Modification to Approved Project
City of Rochester, New Hampshire

Case # 216-11-GRD-14 Property Address 92 Farmington Road

Project name Granite Ridge Marketplace

Waiver Requests – Granite Ridge Marketplace

OVERALL SITE PLAN

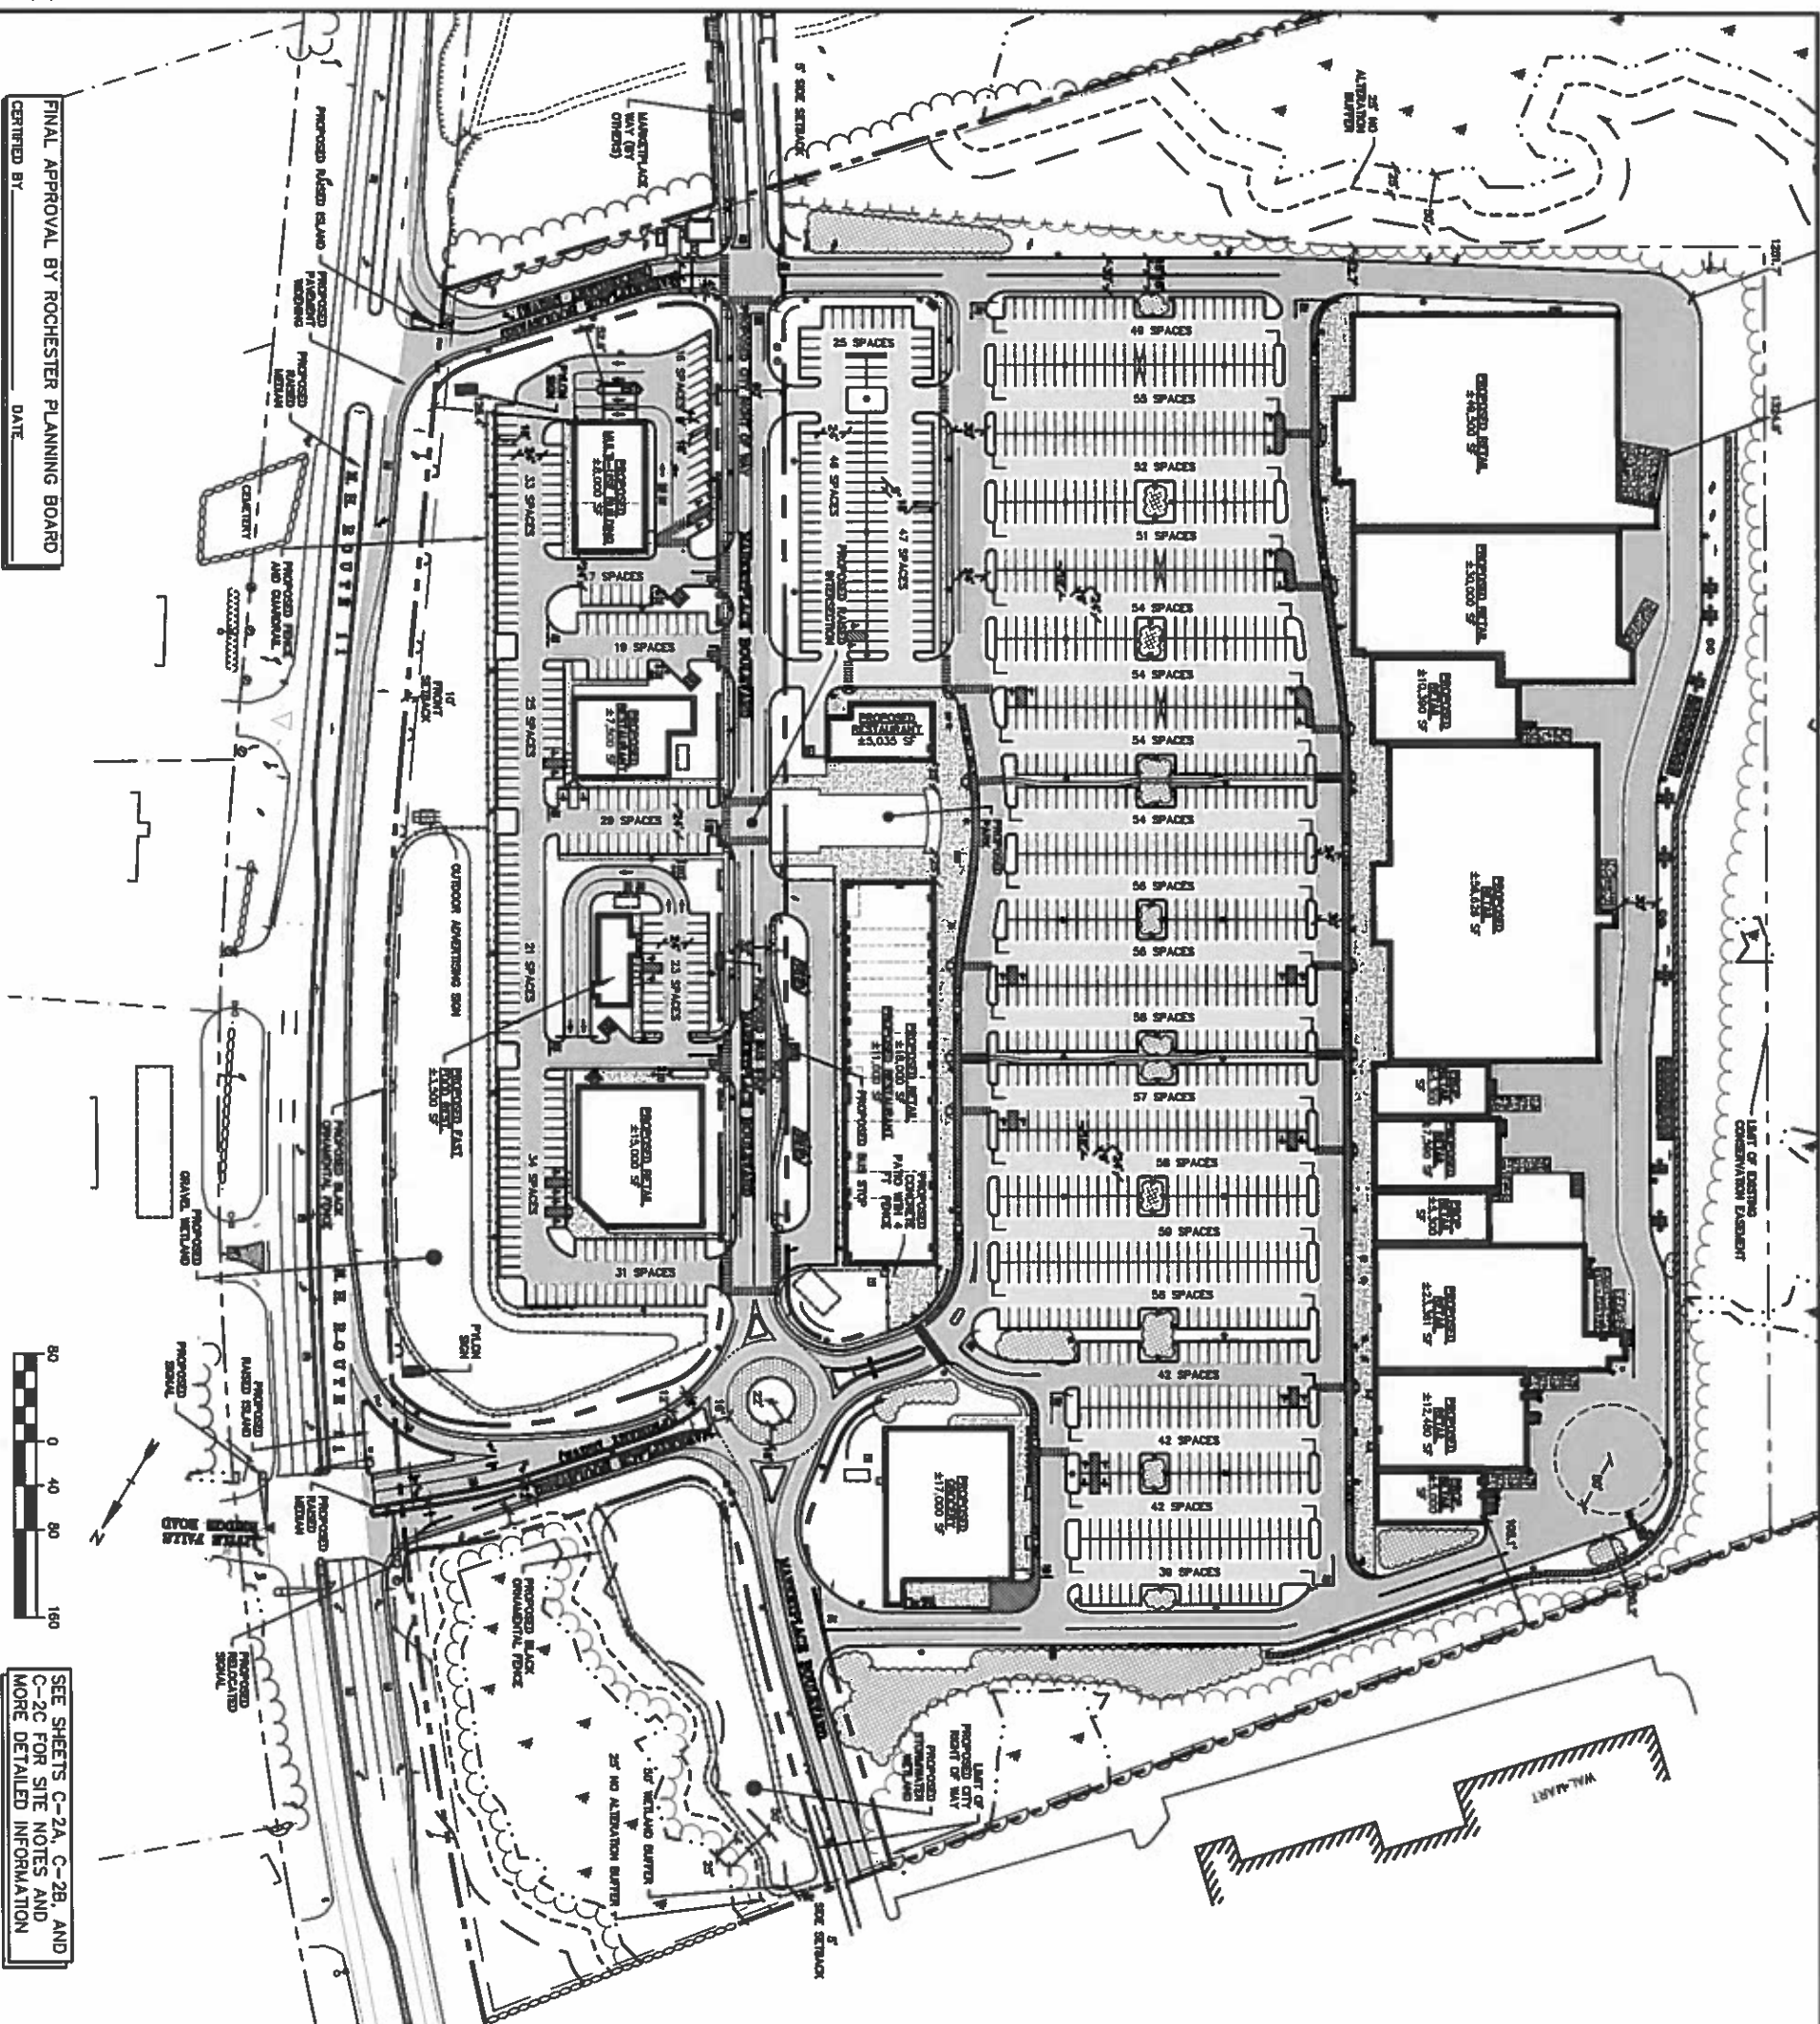
In order to meet the parking requirements of the proposed tenants, we are requesting waivers from the following Site Plan Regulations:

Article III – Section 5 – (E) Parking Lots (5) & (7)

- (5) A landscaping peninsula shall be placed at the end of each parking row (such a peninsula is also referred to as an "end cap"), in line with the adjoining parking spaces, measuring at least the same dimensions as the adjoining parking spaces, wherever the row of parking spaces is adjacent to a perpendicular travel way. Each peninsula shall be planted with one shade tree, or one ornamental tree if use of a shade tree is not practical, for lack of space for roots. Where two peninsulas back up to one another, there may be space for only one ornamental tree (rather than a shade tree) near the tip of each peninsula.

- (7) There shall be no more than four continuous parallel parking rows on the interior of the parking lot (i.e. parking rows along the perimeter of the parking lot are not situated on the interior) without installation of a landscaped median separating those parking rows from any additional parking rows. The landscaped median shall be at least 6 feet wide and shall be parallel to and run the same length as the adjacent parking rows.
